ADDENDUM NO. 1

WASHINGTON STATE PARKS AND RECREATION COMMISSION NISQUALLY STATE PARK NEW FULL-SERVICE PARK PHASE 2 NW-C1218

DATE: May 1, 2024

DEMO & TESC PLAN -
TRAILHEAD
B-D4.1

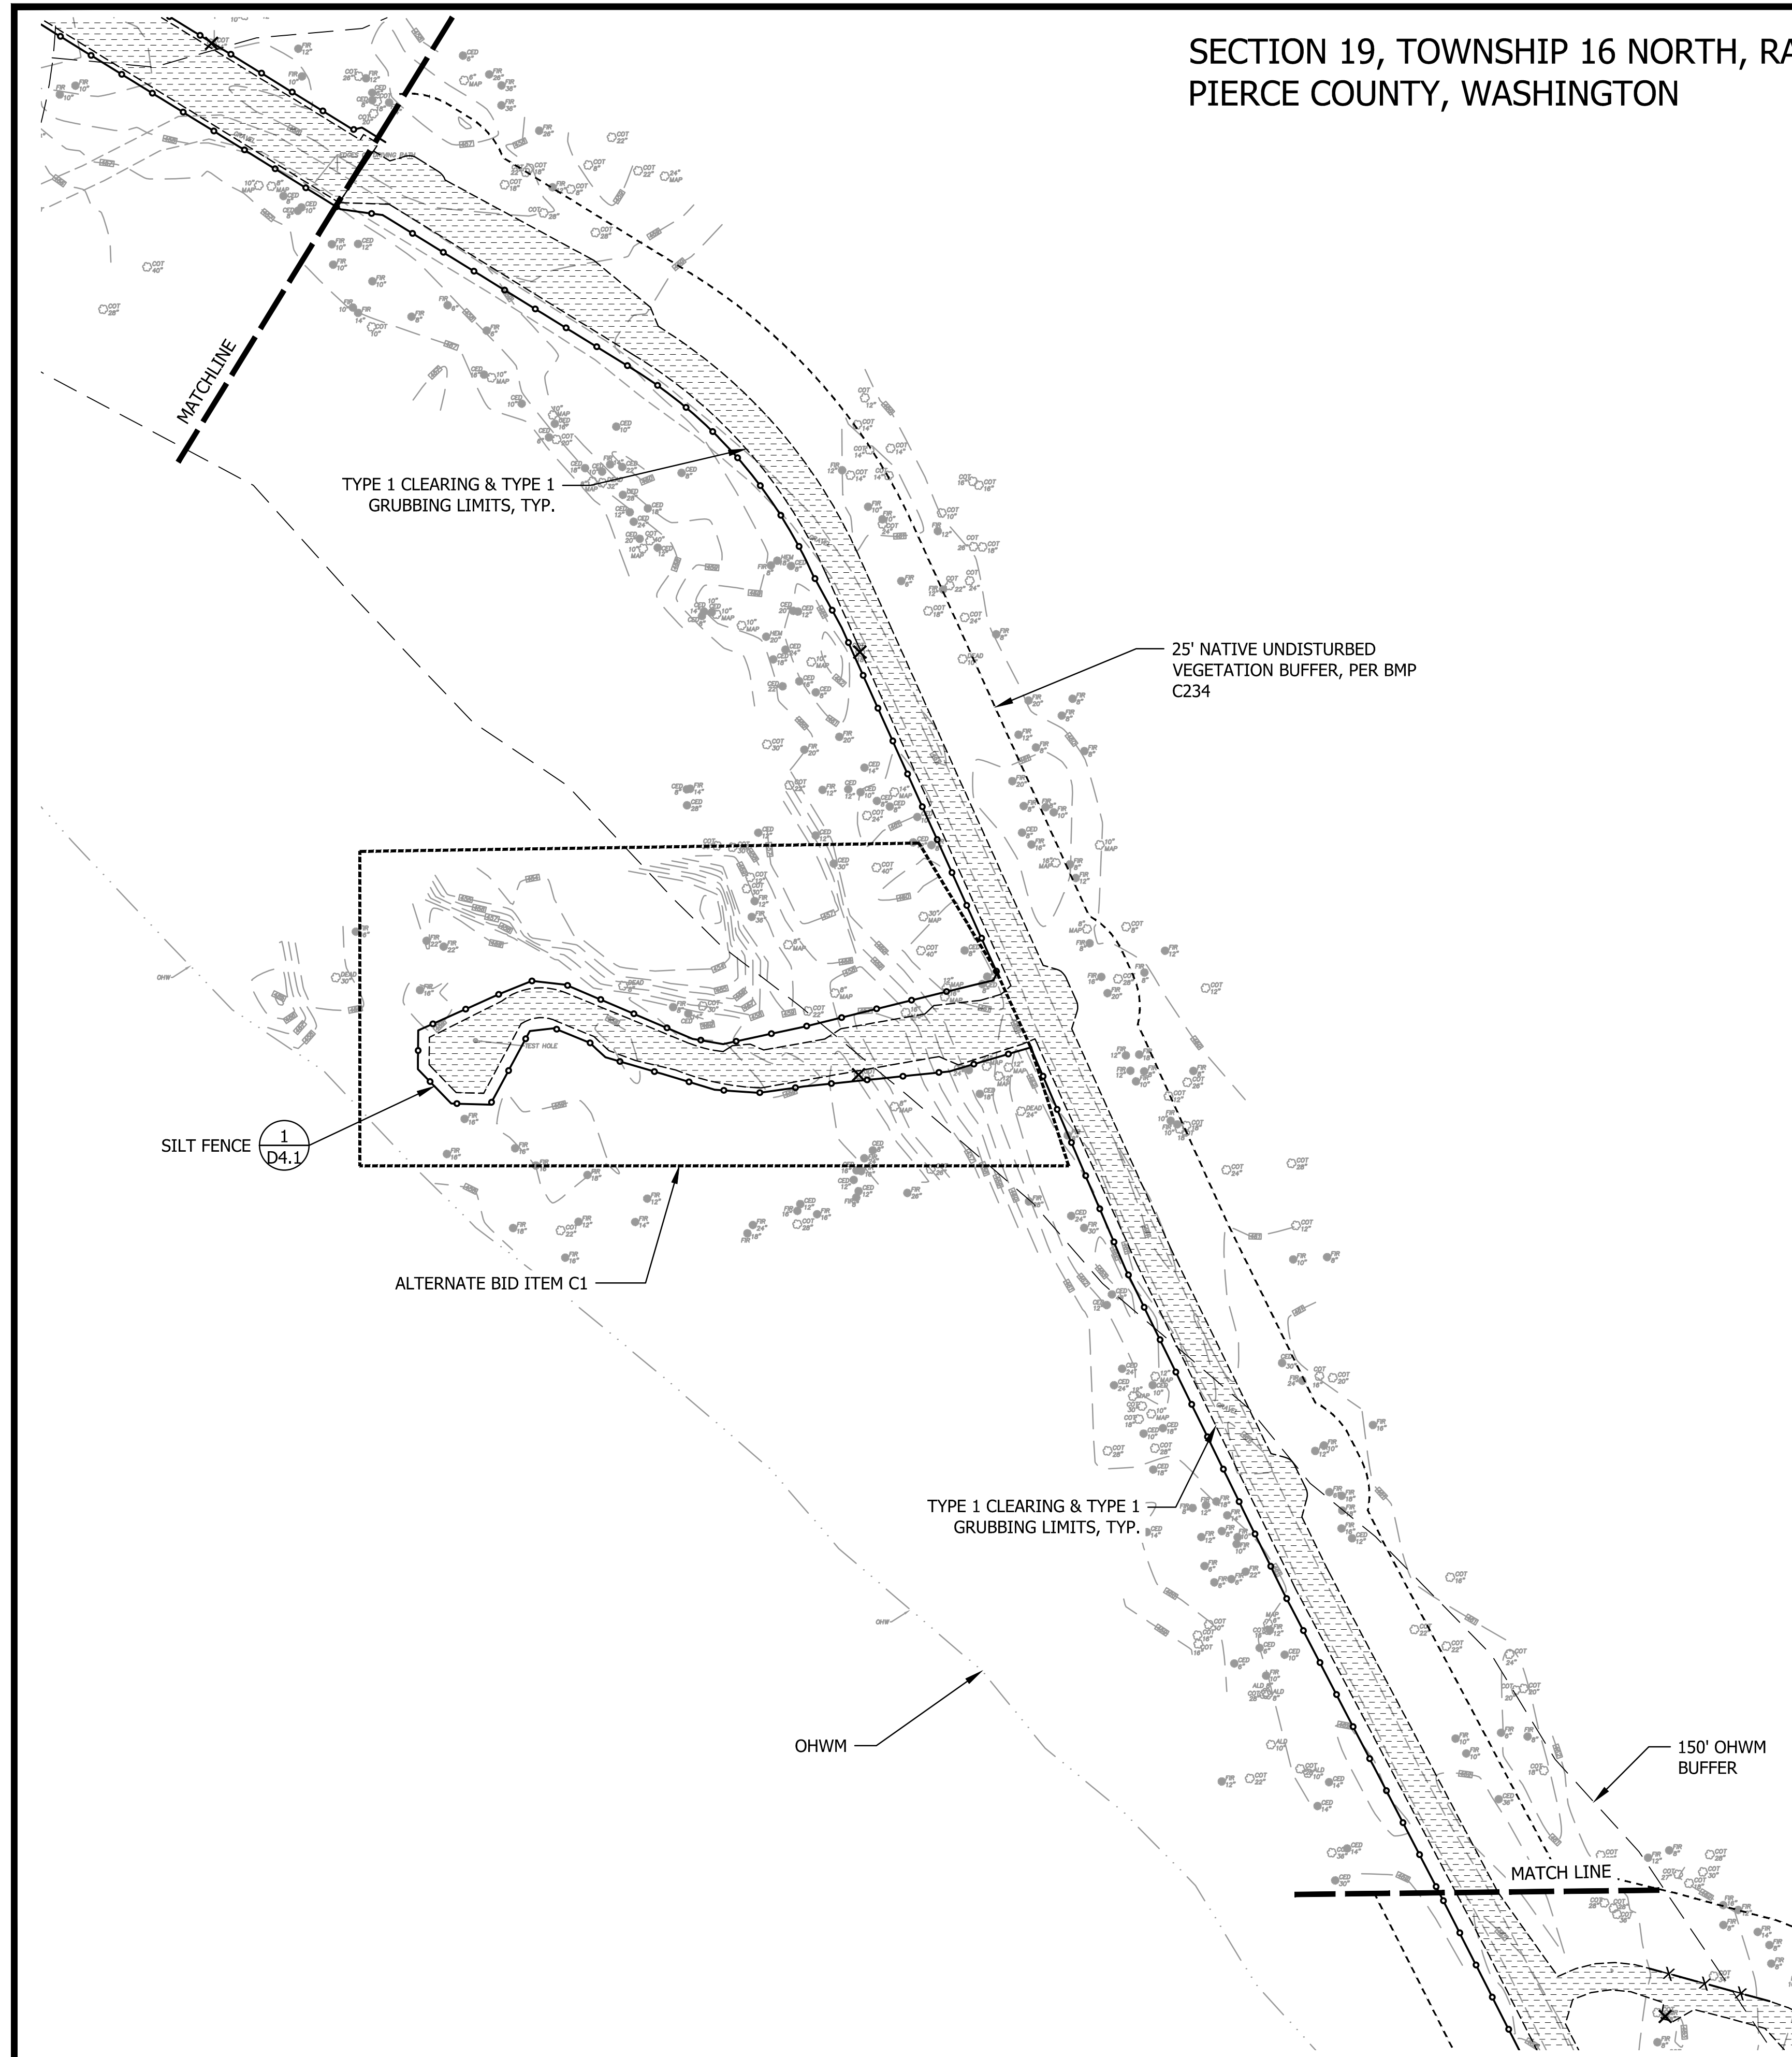
CAD NO.	
DATE	4/29/2024
APP.	
INT.	
REVISIONS	
ADDENDUM #1	NO.
ADDENDUM #1 REVISE GRUBBING TO 12" DEPTH

DEMO & TESC PLAN -
NISQUALLY/OHOP
TRAIL
B-D4.2

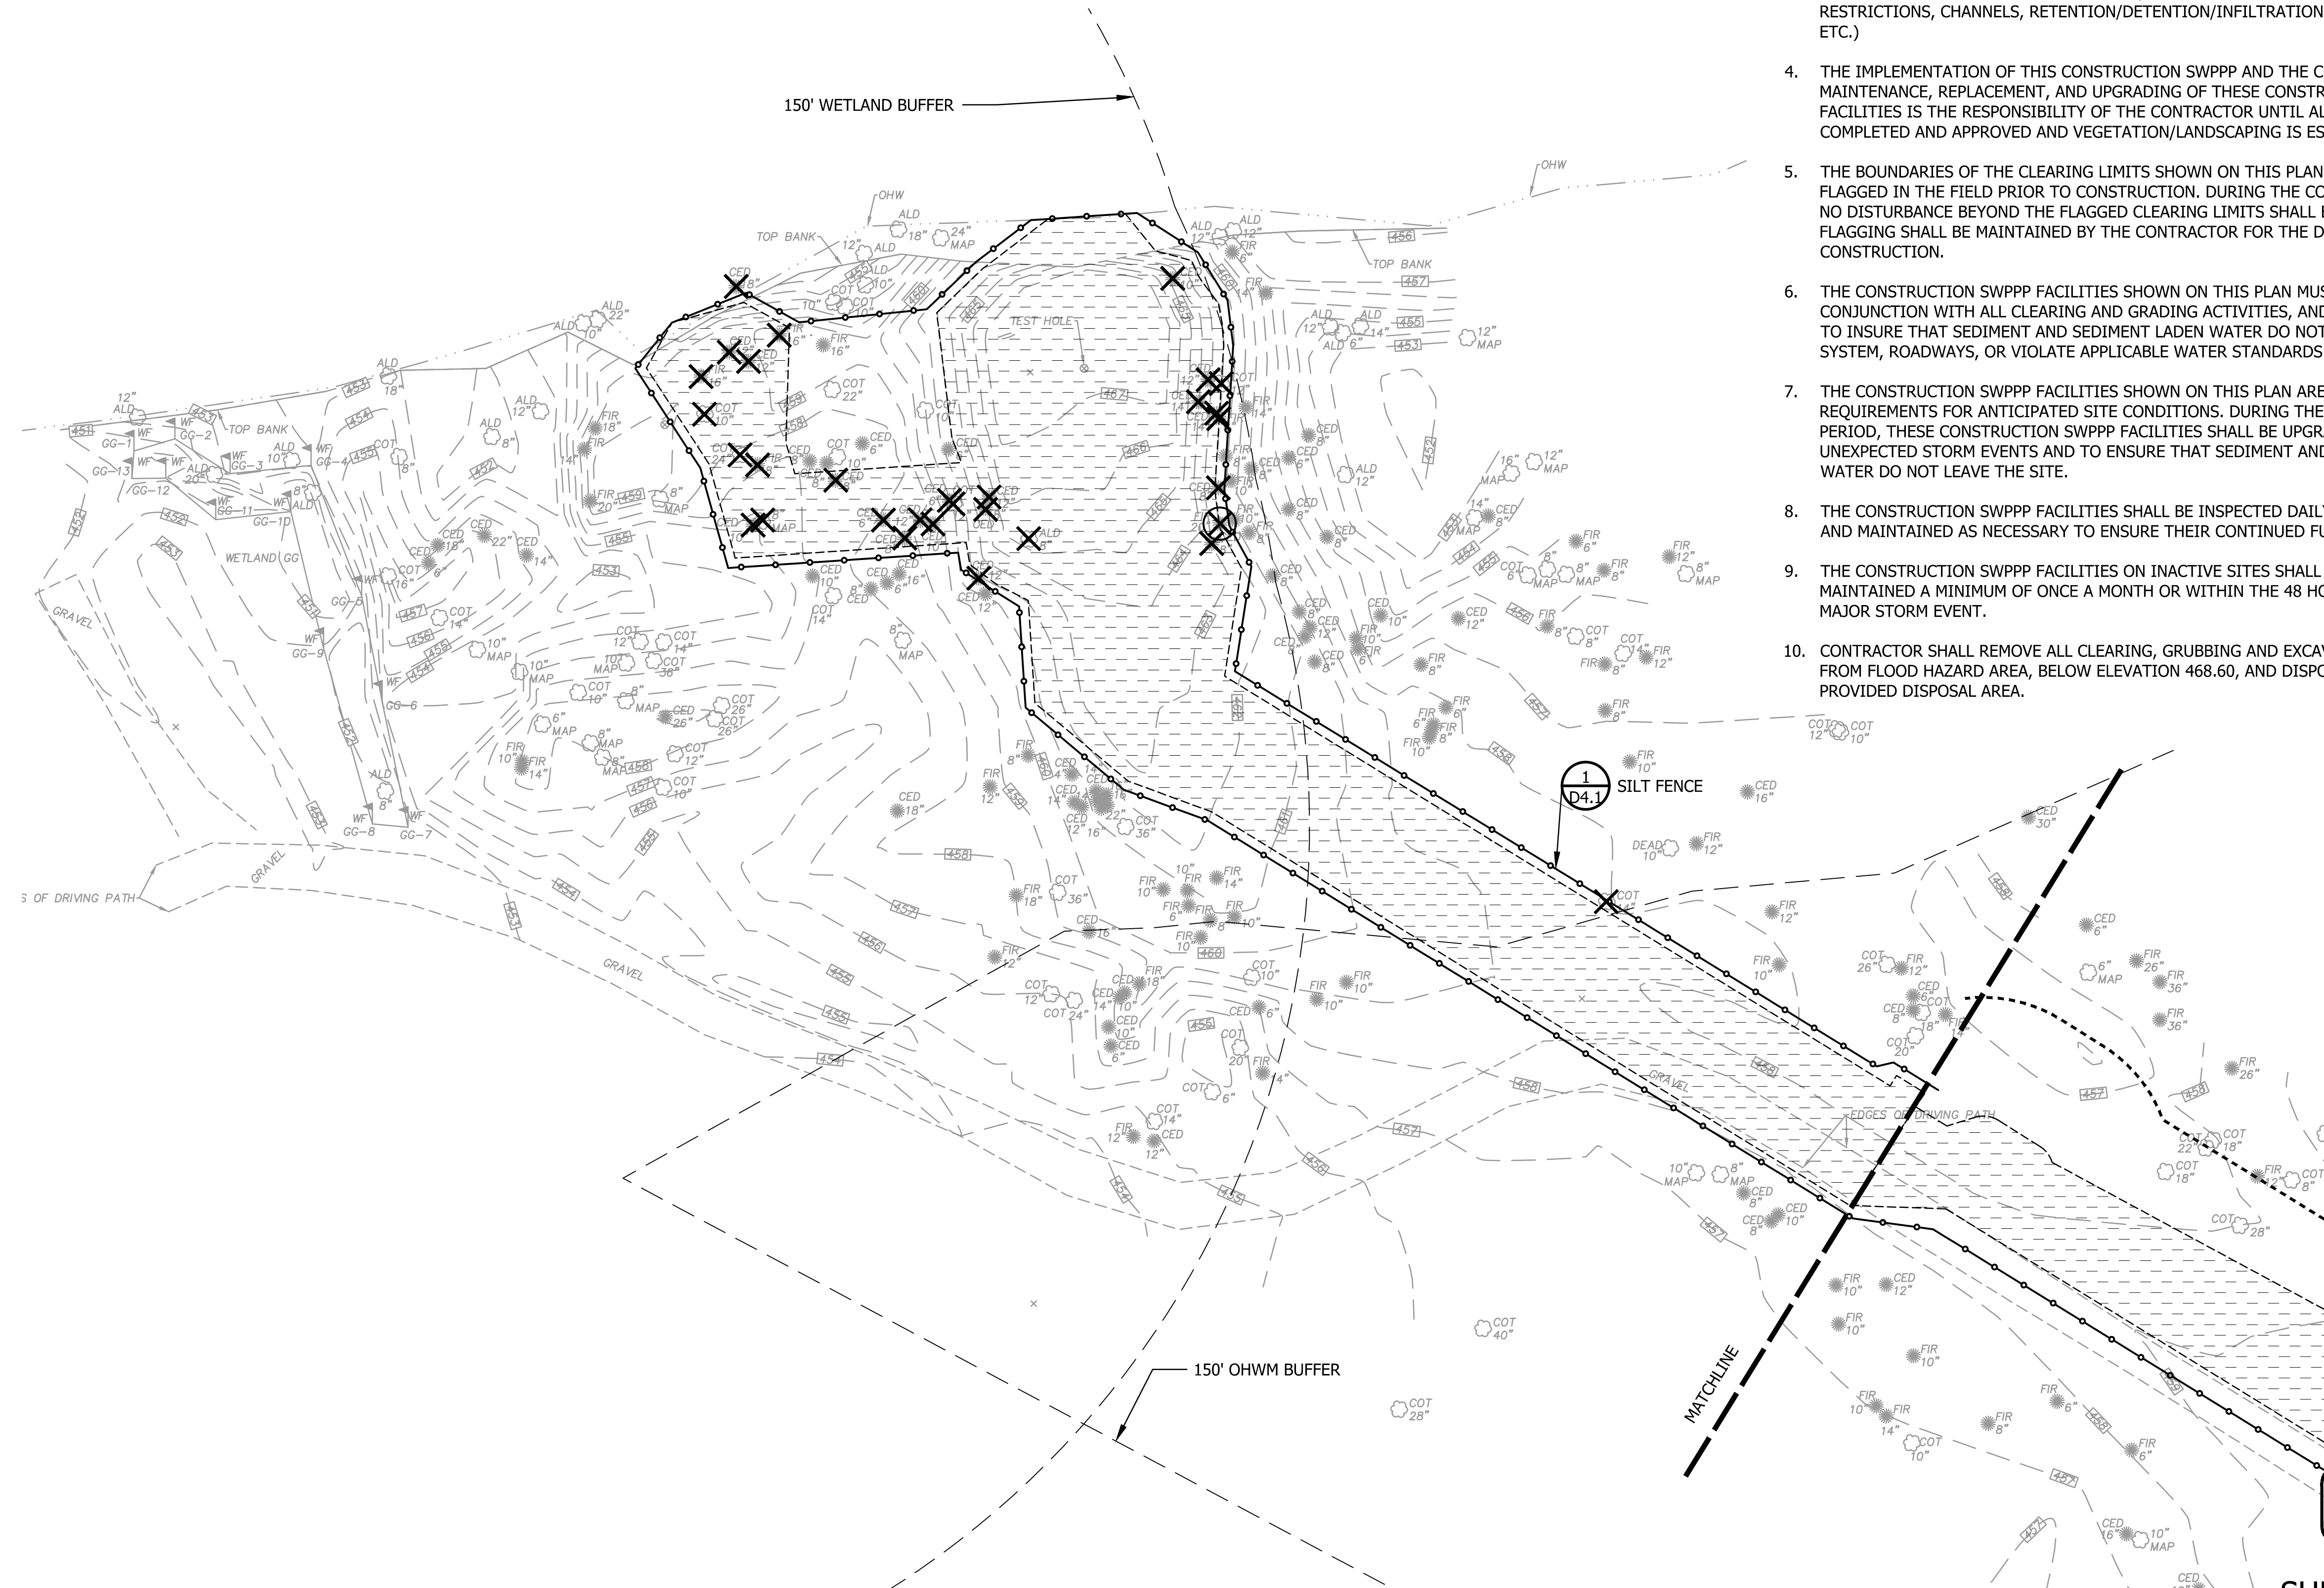
CAD NO.	
4/29/2024	DATE
	APP.
	INT.
ADDENDUM #1	
-REMOVE CEDAR TREES TO BE SALVAGED FOR TRIBE	
REVISIONS	
ADDENDUM #1	NO.
